Illustrated Parts List - IPL Update

H555

Description of change

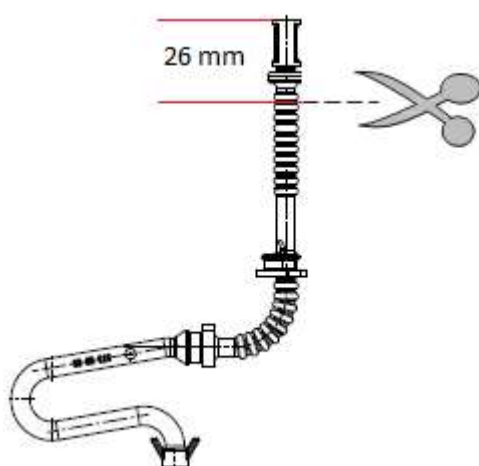
1. New Carburetor, kit 501 46 33-04 added. New angle on fuel nipple.
2. New Fuel hose 577 50 41-01 is 26 mm shorter than old 573 99 35-03 to fit new connection on Carburetor.
3. Choke control changed to secure correct assembly.

When you don't want to change to the new fuel hose included in kit, Carburetor.
Cut your old hose like this:
